City of Santa Barbara California

PLANNING COMMISSION STAFF REPORT

REPORT DATE: May 7, 2009
AGENDA DATE: May 14, 2009
PROJECT ADDRESS: 3714-3744 State Street (MST2007-00591)
 "Sandman Project"
TO: Planning Commission
FROM: Planning Division, (805) 564-5470
 Danny Kato, Senior Planner *DK*
 Allison De Busk, Project Planner *AD*

View 1 Simulation

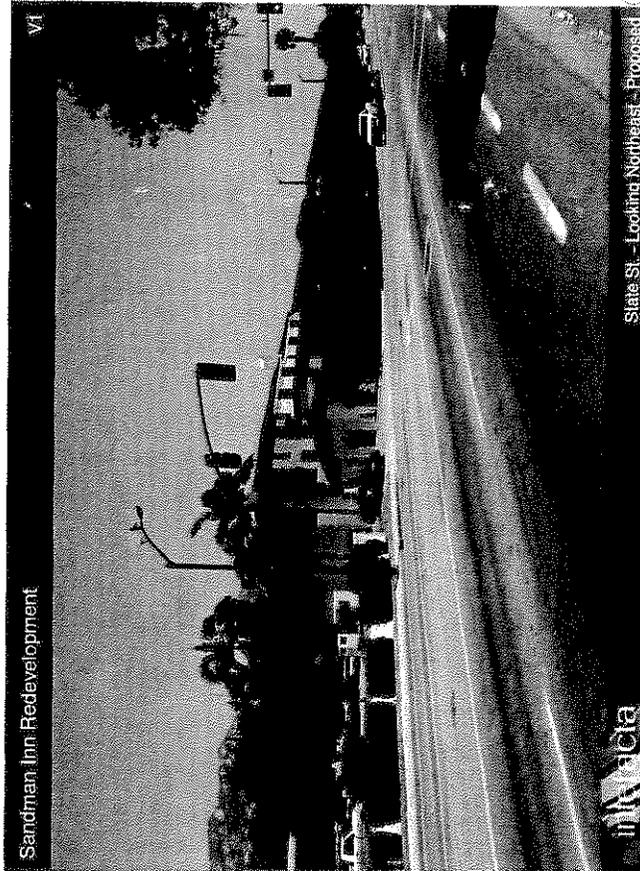
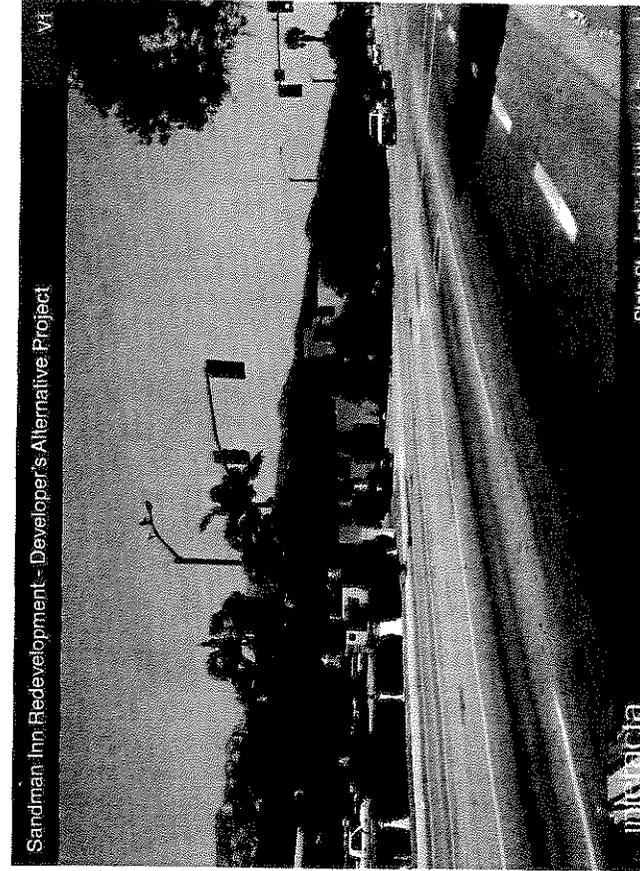
mountain view corridors. Specifically, the USSS states that views at intersections should be protected. The proposed project has a greater impact on the availability of mountain views as seen from the State/Hitchcock intersection than the applicant's alternative. Staff believes that the applicant's alternative would be consistent with the Conservation Element and USSS view policies; however, the proposed project would not be. Based on City policy, does the Planning Commission believe that either project could be found consistent with the goal of protecting mountain views?
